Access Compliance Report

Public Rights-of-Way

Intersection ID: 13639	Main Street: BRIAR_CREEK_RD	Cross Street: CENTRAL_AV	Location: SW
ADA ID: CF846A4F985D	Ramp Type: PerpDiag	Initial Pass/Fail: Fail	Overall Compliance: No
		Severity Score: 22.5

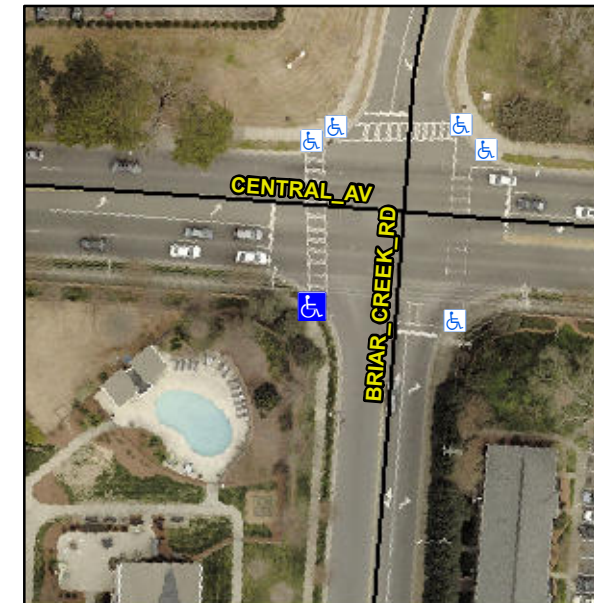
Not Found, R304.5.1, R304.2.2

Compliance	Description	Data	Compliance	Description	Data
N/A	Ramp Length (in)	60.0	No	Ramp Slope (%)	9.5
No	Ramp Width (in)	46.0	Yes	Ramp XSlope (%)	3.8
N/A	Flare Type LT	N/A	N/A	Flare Type RT	N/A
N/A	Flare Slope LT (%)	N/A	N/A	Flare Slope RT (%)	N/A
N/A	Flare Traversable LT?	N/A	N/A	Flare Traversable RT?	N/A
N/A	Landing Length (in)	N/A	N/A	DWS Provided?	N/A
N/A	Landing Width (in)	N/A	N/A	DWS Contrast?	N/A
N/A	Landing Slope (%)	N/A	N/A	DWS Length (in)	N/A
N/A	Landing X Slope (%)	N/A	N/A	DWS Full Width?	N/A
N/A	Landing Curb? (Y/N)	N/A	N/A	DWS Offset (in)	N/A
N/A	Shared Landing?	N/A			
N/A	Gutter Ponding?	N/A	N/A	Gutter Slope (%)	N/A
N/A	Gutter Lip Ht (in)	N/A	N/A	Gutter X Slope (%)	N/A
N/A	Painted X Walk1?	Yes	N/A	Painted X Walk2?	Yes
	X Walk 1 Direction	To SE		X Walk 2 Direction	To N
N/A	X Walk 1 Width (in)	119.0	N/A	X Walk 2 Width (in)	100.0
	X Walk 1 Slope (%)	1.3		X Walk 2 Slope (%)	4.7
	X Walk 1 X Slope (%)	3.4		X Walk 2 X Slope (%)	3.2

Remove & Replace Curb Ramp With Two New Directional Ramps or Equivalent.
